# ADUR DISTRICT COUNCIL

<b>Adur Planning Committee</b>	
<b>Date:</b>	<b>5 September 2022</b>
<b>Time:</b>	<b>7.00 pm</b>
<b>Venue:</b>	<b>QEII Room, Shoreham Centre, Shoreham-by-Sea</b>

## ADDENDUM REPORTS

<b>Application Number:</b>	AWDM/1481/21	<b>Recommendation - Approve subject to a s.106 Agreement, the receipt of amended plans and outstanding consultee responses.</b>
<b>Site:</b>	Land At Former 5 Brighton Road, Shoreham-By-Sea	
<b>Proposal:</b>	<b>Proposed mixed-use re-development between 3 and 8 storeys comprising 21 townhouses, mixed-use apartment block of 24 flats, riverside walk, landscaping, and parking.</b>	
<b>Applicant:</b>	Cayuga 011 LLP	Ward: Southwick Green
<b>Agent:</b>	Lewis and Co Planning SE Ltd	
<b>Case Officer:</b>	Stephen Cantwell

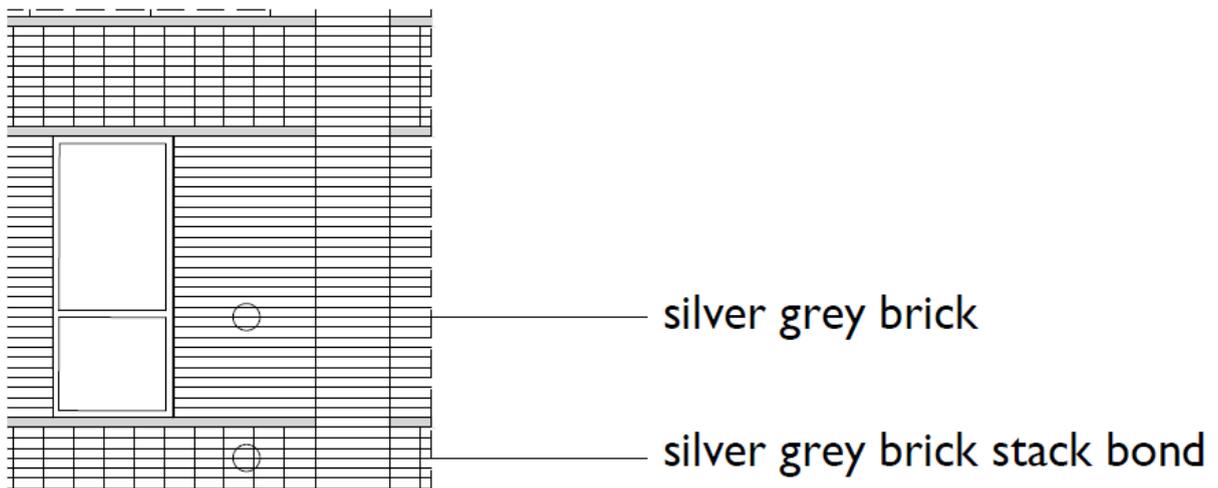
Proposed brick colour: The photo below shows a close-up of the proposed brick, it is clearly a silver-grey not a grey-grey concrete colour. It has a variegated surface and is very light responsive

the proposed image of the courtyard (below) contains a close-up of the brick, this is taken from an actual photo of the proposed brickwork.

Generally, the brickwork is a stretcher bond unless otherwise stated. The stack bond is only used on the four storey houses and in defined panels framed by the vertical piers and the secondary red/brown secondary brick string courses. The concept is to provide a variety of visual texture to the elevations & to give the 4-storey houses a subtly different look to the other two blocks.

The secondary red brown brick makes a reference to the bricks of the adjoining Kingston Wharf development. It is used for string courses through the development and as the main brick to the links between the housing terraces and flats block to provide a visual separation. It is also used on the back walls to the recessed balconies in the flats block to provide visual contrast & depth to the elevations

The clarification of brickwork bond shows considered and selective use of stack bound on areas of the four storey terraces only. Whether the grey shade and texture as indicated is suitable. Officers have reservations and consider that a shade which is closer to that of the lighthouse would be appropriate here, but acknowledge that this is a matter of judgement. Samples of materials would be required, which could be achieved under the proposed condition no.6.
